UNITED STATES PATENT AND TRADEMARK OFFICE

APPLICATION NO.	FILING DATE	FIRST NAMED INVENTOR	ATTORNEY DOCKET NO.	CONFIRMATION NO.
10/088,645	04/18/2002	Joseph Crestin	P22017	7435

Office Action Summary	Application No.		Applicant(s)	
	10/088,645		CRESTIN ET AL.	
	Examiner		Art Unit	
	Aaron M Dunwoody		3679

DETAILED ACTION

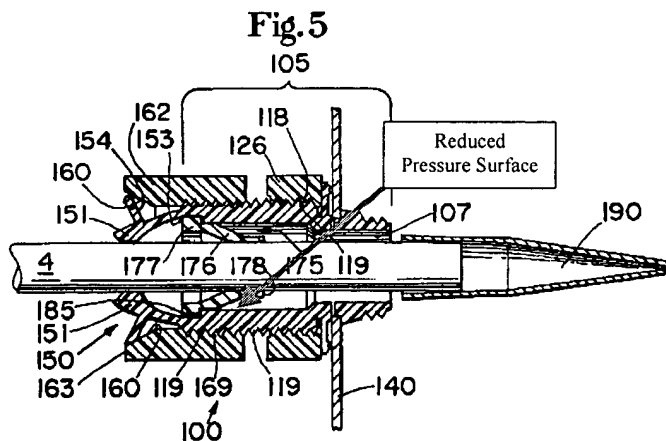
In regards to claim 1, Sheehan discloses a device for axial maintenance of a cylindrical element, comprising a coupling bushing (105) which is threaded externally (119) and which is prolonged in the axial direction by tightening nut strips (151), and a covering nut (162) comprising internally a reduced pressure surface (160) intended to act on the ends of the nut strips of the coupling bushing and to deform them radially towards the cylindrical element (4) previously introduced into the coupling bushing after crossing the nut, the device characterised in that it further comprises a sleeve (175) whose external diameter is at most equal to the internal diameter of the coupling bushing in which the sleeve is intended to be introduced beginning by the strips with which it is provided, the coupling bushing being further provided internally with a reduced pressure surface (see figure 5

below).

Sheehan does not

disclose a sleeve provided with nut strips. Robertson teaches a sleeve (12) provided with nut strips "to further improve the seal action of the fitting" (col. 3, lines 58-59). It would have been obvious to one having ordinary skill in the art at the time the invention was made to provide a sleeve with nut strips to further improve the seal action of the fitting, as taught by Robertson.
